West Parcel Solar Project

Project Final Tiered EIR

***Volume 4
Response to Public Comments on the Draft EIR
Appendices***

UWT Response to the July 2017 NOC of Tiered Draft EIR for the Mt. SAC West Parcel Solar Project

Hillside Losses from Solar Project Traveling form Snow Creek Drive to Amar Road

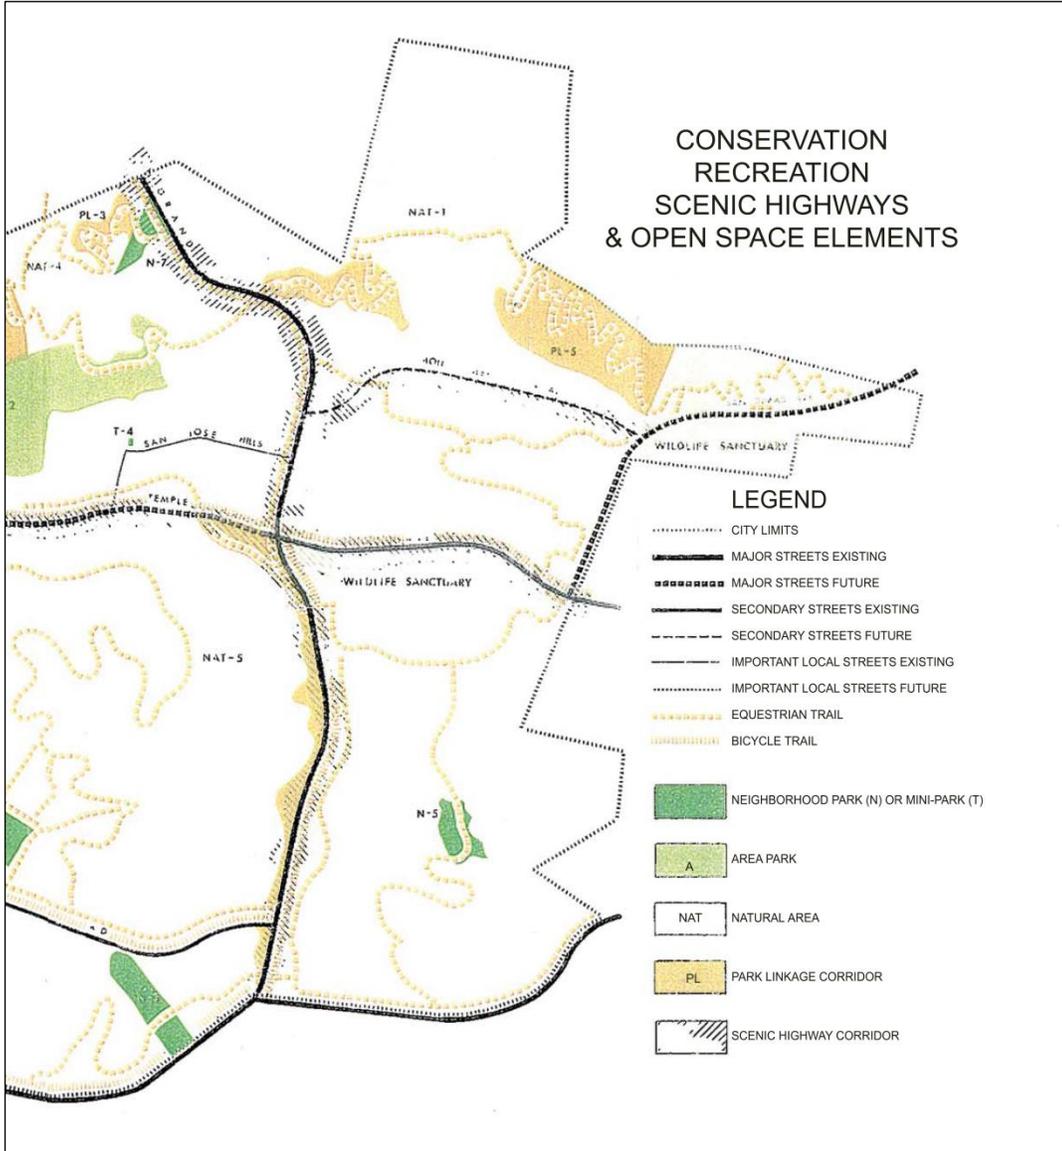
5. Motorists traveling Grand Avenue would observe loss of hillsides, which is inconsistent with the General Plan Scenic Corridor designation of the roadway. The following views of Grand Avenue (photos 1 through 3, below) traveling from south to north from Snow Creek Drive to Amar Road displays the scenic values of Grand Avenue at street level and the significant destruction of native hillsides and vegetation caused by the west parcel project.

Superimposed Hwy
Cut Slope – Ref. 1979 LA
County Construction
Plans

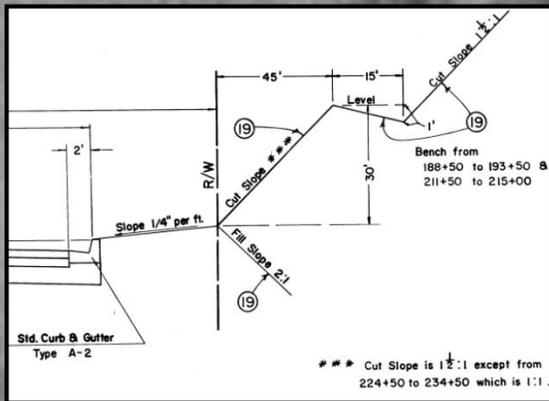
TSI conducted a brief review of the potential for landsliding at the site. A review of aerial imagery from Google Earth clearly indicates a landslide(s) exists on the eastern side of the central hillside area descending to Grand Avenue (Photo's 1 and 2). This landslide area is present in aerial imagery dating from after 1980 until the present. The presence of this landslide complex was further confirmed based on the brief field reconnaissance on March 30, 2017. In addition, siltstone and shale bedrock with eastward dipping (toward Grand Avenue) bedding was also observed in this area.
